# HISTORIC AND DESIGN REVIEW COMMISSION

May 17, 2017

**HDRC CASE NO:** 2017-180  
**COMMON NAME:** 421-425 E MISTLETOE  
**LEGAL DESCRIPTION:** NCB 863 BLK LOT 14 E 45.5 FT OF 13 & W 4.5 FT OF 15  
**ZONING:** RM-4  
**CITY COUNCIL DIST.:** 1  
**APPLICANT:** Ricardo Turrubiates/Tarramark Urban Homes  
**OWNER:** K/T TX Holdings, LLC  
**TYPE OF WORK:** Construction of housing development

Mistletoe - Building 2

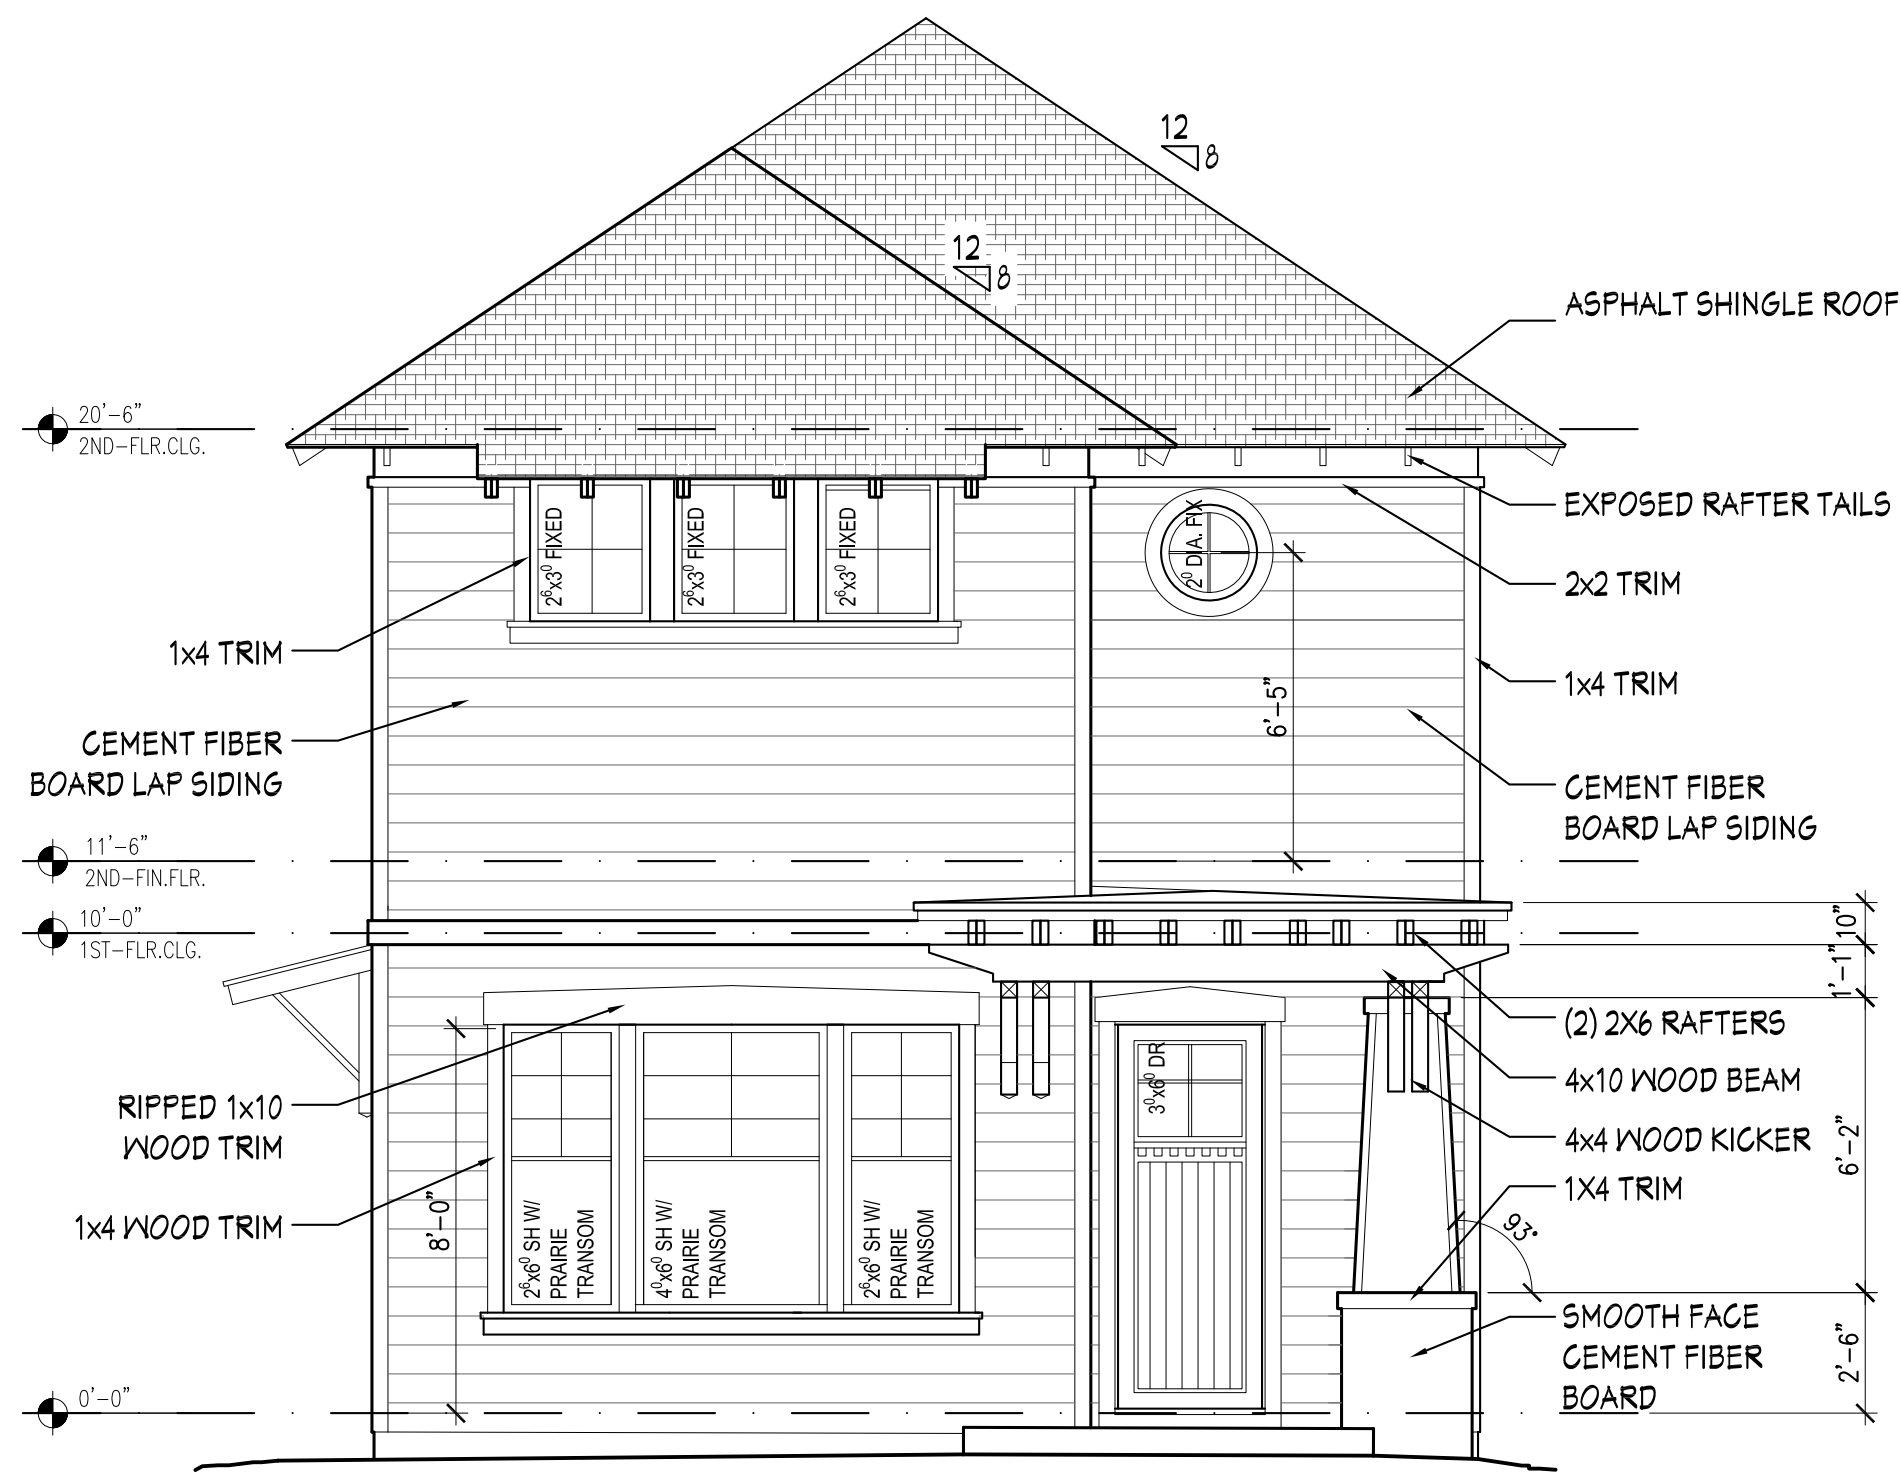
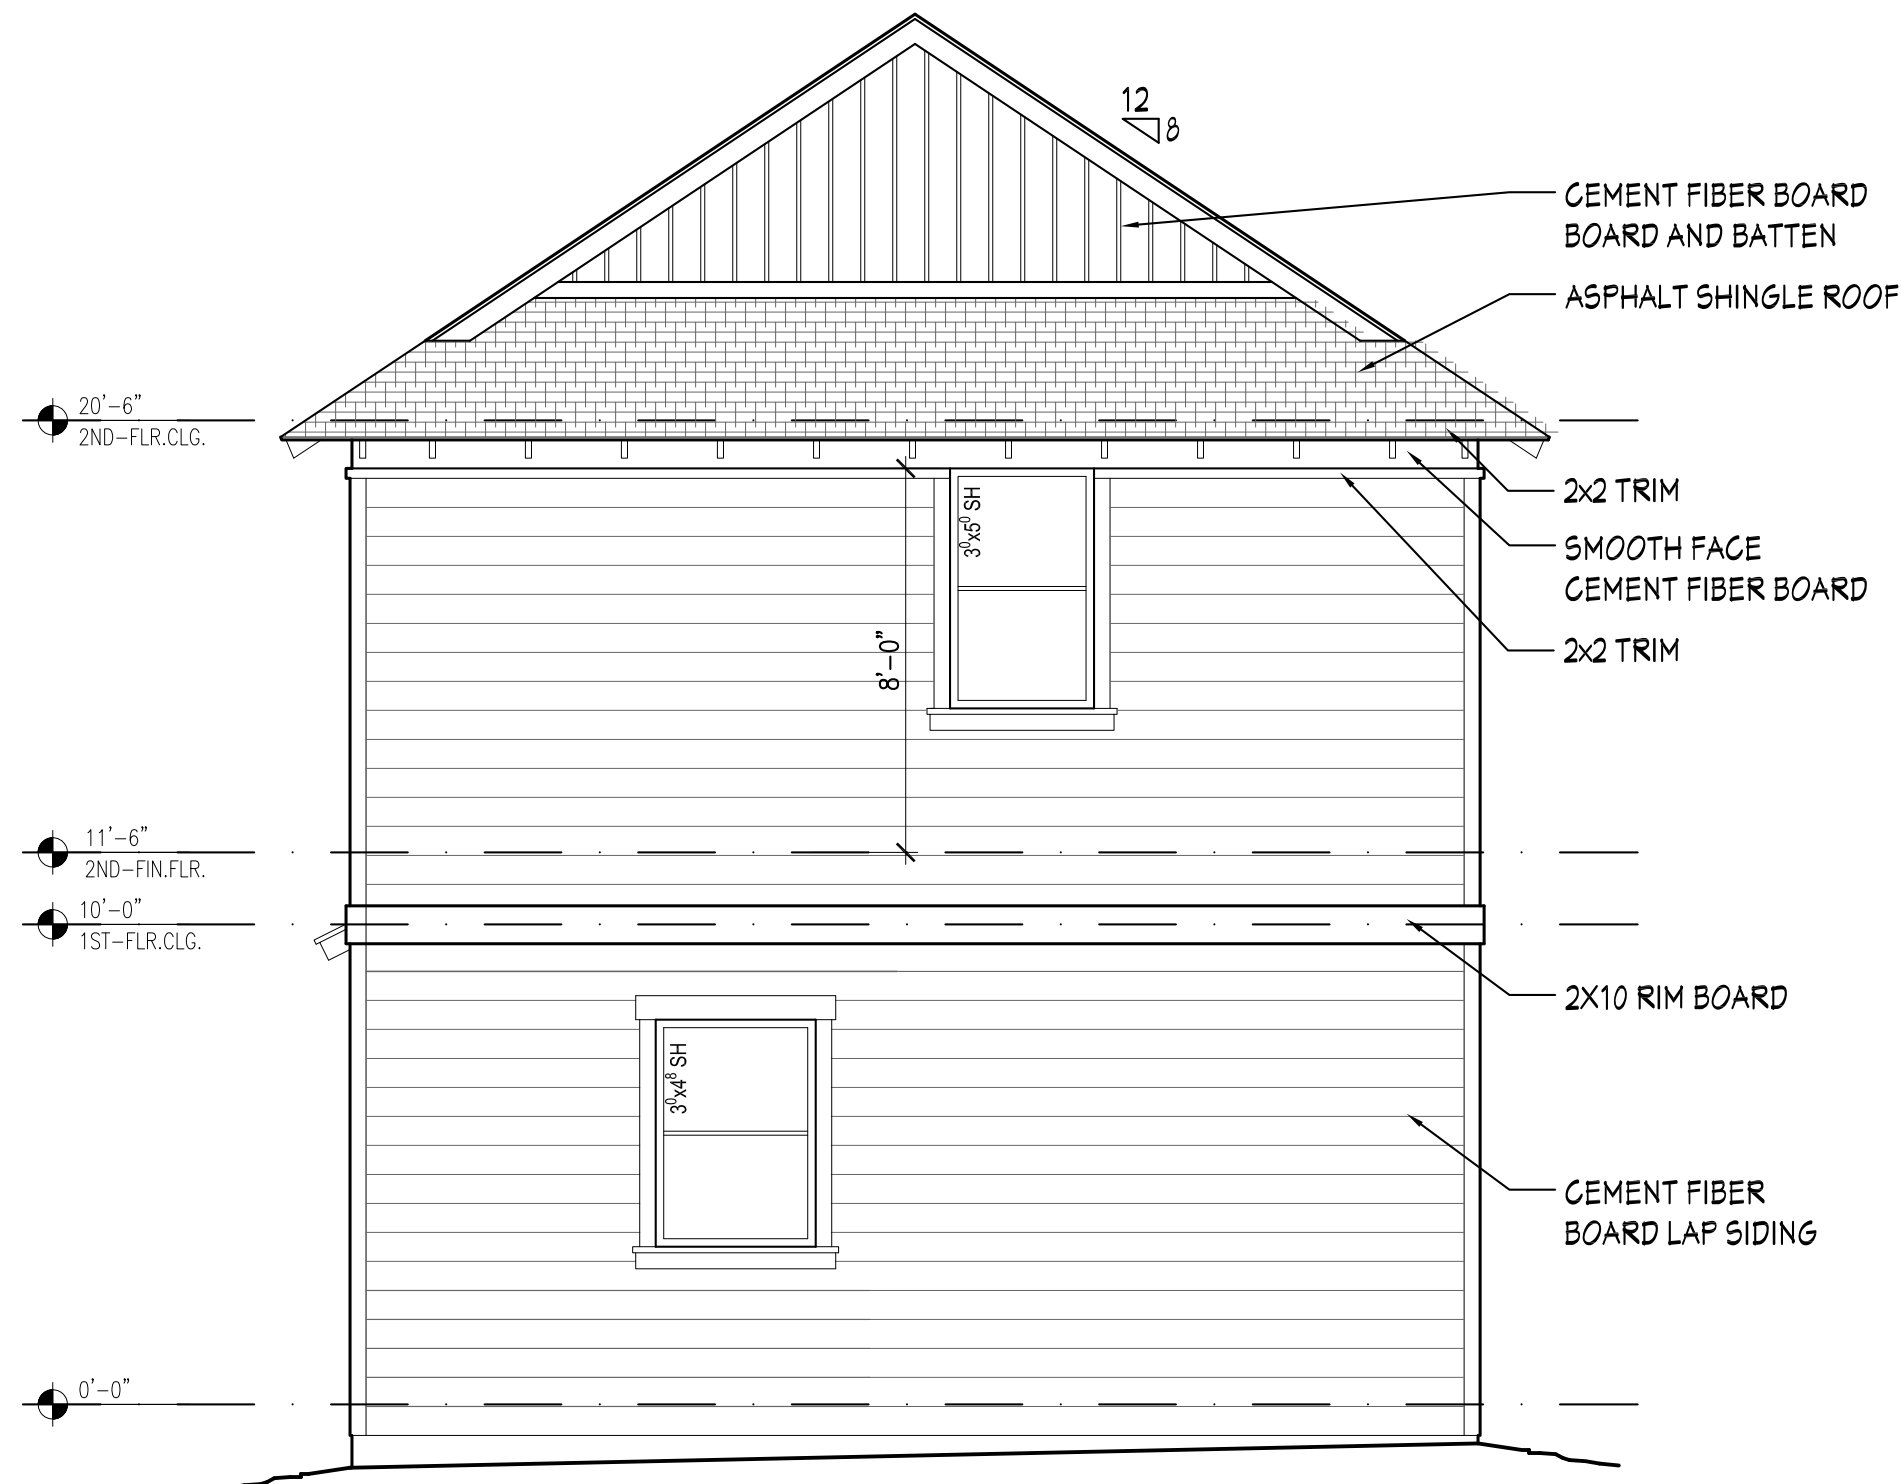
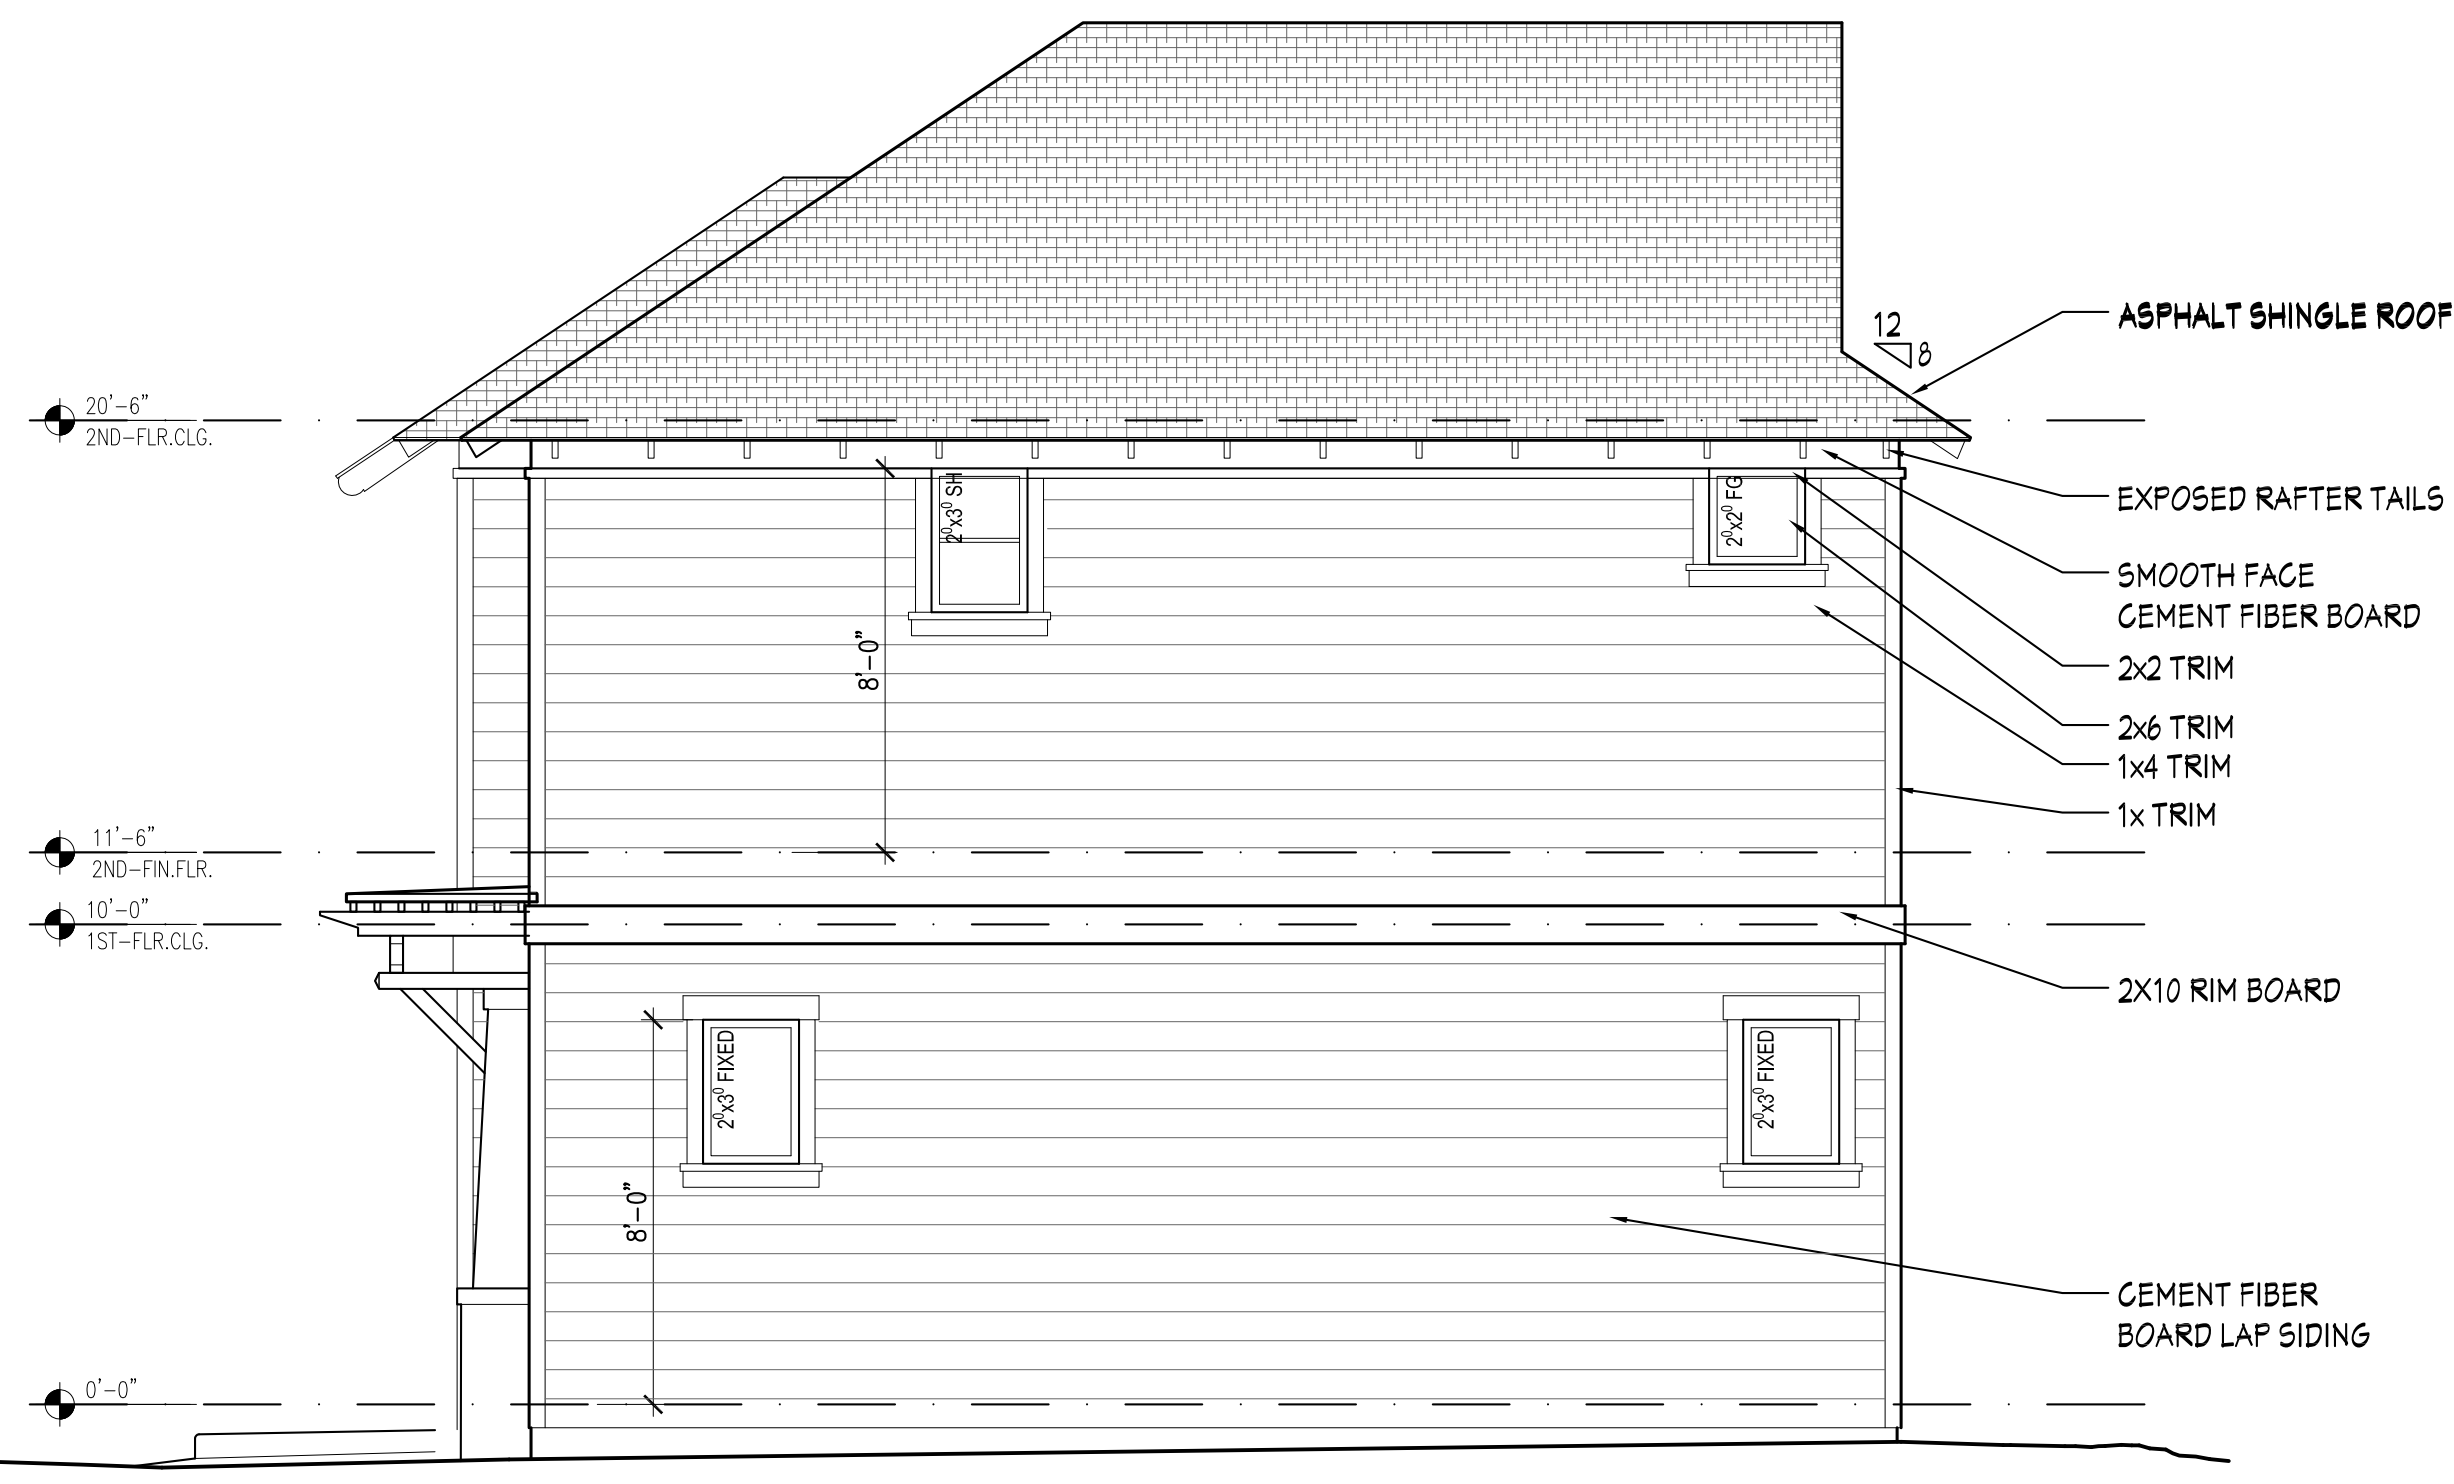
- g. **WINDOW AND DOOR PLACEMENT** – The proposed design for Building 1, Building 2, and Prototype 4.2B include the placement of windows and doors, including their trim, directly abutting rim board, roof trim pieces, and/or fiberboard on every elevation. This direct adjacency of materials and façade elements is not typical of historic approaches to fenestration. Additionally, on some elevations, the blank wall space between openings exceeds the continuous wall space recommendations in the guidelines.

- j. BUILDINGS 1 AND 2 – Building 1 and Building 2 were submitted in the proposal heard by the HDRC on April 19, 2017. In staff recommendations, as well as at the hearing, it was noted that the windows did not comply with the OHP Window Policy document. It was also noted that these buildings did not feature full porches with two columns. The suggested modifications have not been made since the last hearing.

- a. The applicant explores designs that respond to the context of the district versus utilizing designs that are built or proposed in other parts of the city.
- b. The applicant explores 1.5 story options or prototypes with a modified roof pitch to respond to the dominant historic massing context of the neighborhood.
- c. Fenestration patterns on all prototypes are revised to be more consistent with the size and placement common of historic facades in the district.
- d. That the front porch configuration for Prototype 1436 is modified to include two columns that project from the façade and engage the streetscape.
- e. That the proposed windows are true divided lites or a 1 over 1 configuration with wood screens featuring divided lites to reflect window configurations common in the district and the proposed modern Craftsman approach.
